UNITED STATES PATENT AND TRADEMARK OFFICE

Office Action Summary	Application No. 10/783,119	Applicant(s) COOPER, BRADLEY	
	Examiner Alissa L. Hoey	Art Unit 3765

DETAILED ACTION

Fig. 1

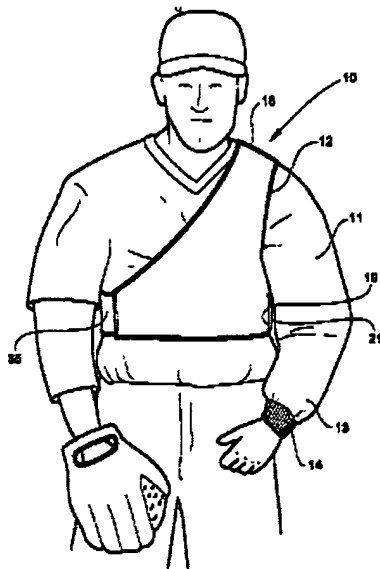
In regard to claims 1-3, Dellinger provides a warm-up jacket (10) for a pitcher having a portion that surrounds the upper extremity below the wearer's arm (11). A portion of the jacket (10) extending over the front chest quadrant (12), shoulders (18) and at least a portion of a first arm (11). A second arm and associated upper extremity and shoulder region are not covered by the jacket (figure 1). The arm covered (11) by the jacket (10) is the arm used in pitching and a fastener element (40, 41) permitting the region portion of the jacket surrounding the chest to be separated.

In regard to claims 7-9, Dellinger provides a jacket (10) having a portion covering at least one arm (11) and associated regions of the abdomen (22, 28), an aperture (23, 24) in the jacket (10) exposing a second arm and associated regions of the abdomen. A lower portion (28) for securing the jacket to the abdomen including a fastener (40, 41). The jacket (10) permits one arm (11) and associated regions to retain heat (column 1, lines 65-67).
